**DEFENSE NUCLEAR FACILITIES  
SAFETY BOARD**

## Staff Report

February 11, 2019

### Y-12 National Security Complex Criticality Safety Review

**Figure 1.** NCS Organization Staffing as of January 2019

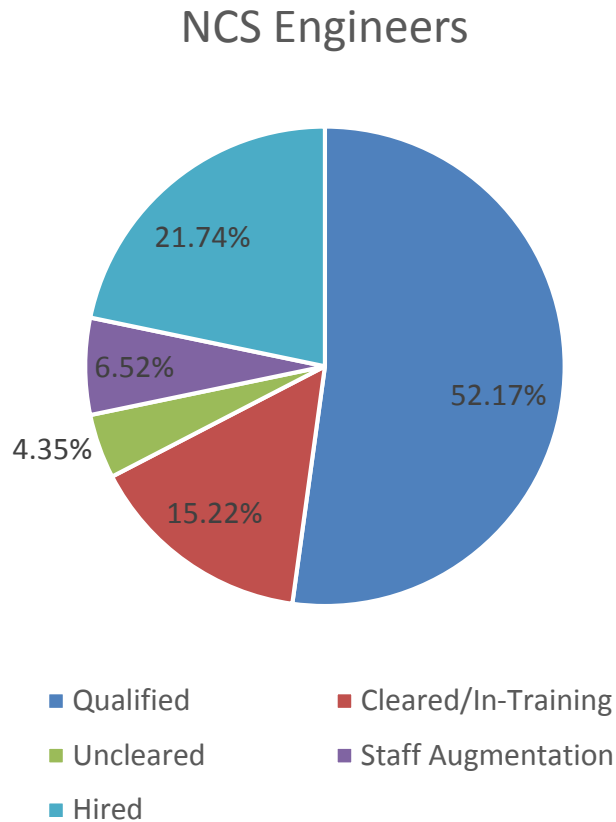
*Inability of the NCS Organization to Adequately Maintain the Y-12 Criticality Safety Program*—The Y-12 NCS organization lacks sufficient qualified staff to perform both CSP continuous improvement activities and Operations-directed work. As shown in Figure 1, approximately 52 percent of the engineers in the Y-12 NCS organization are qualified (including subcontractors identified as staff augmentation), the remainder are in-training. Qualifications for in-training NCS engineers have been delayed for various reasons, including delays in obtaining DOE security clearances. As of November 2018, the number of qualified NCS engineers does not match the number of NCS engineers required to meet the scope of work budgeted for a given fiscal year. Additionally, the site struggles to retain qualified engineers. On average the number of new NCS engineers hired has equaled the number of NCS engineers lost in a given fiscal year since FY 2015 [18-21].

The staff team acknowledges recent Y-12 efforts to increase NCS staffing. However, the staff team is concerned that the NCS organization cannot sufficiently staff both its commitments to Operations and to perform continuous improvement work on the CSP (e.g., updating/upgrading CSEs) until the number of qualified NCS engineers is increased. The staff team concludes the challenge of retaining NCS engineers will continue to put a strain on the
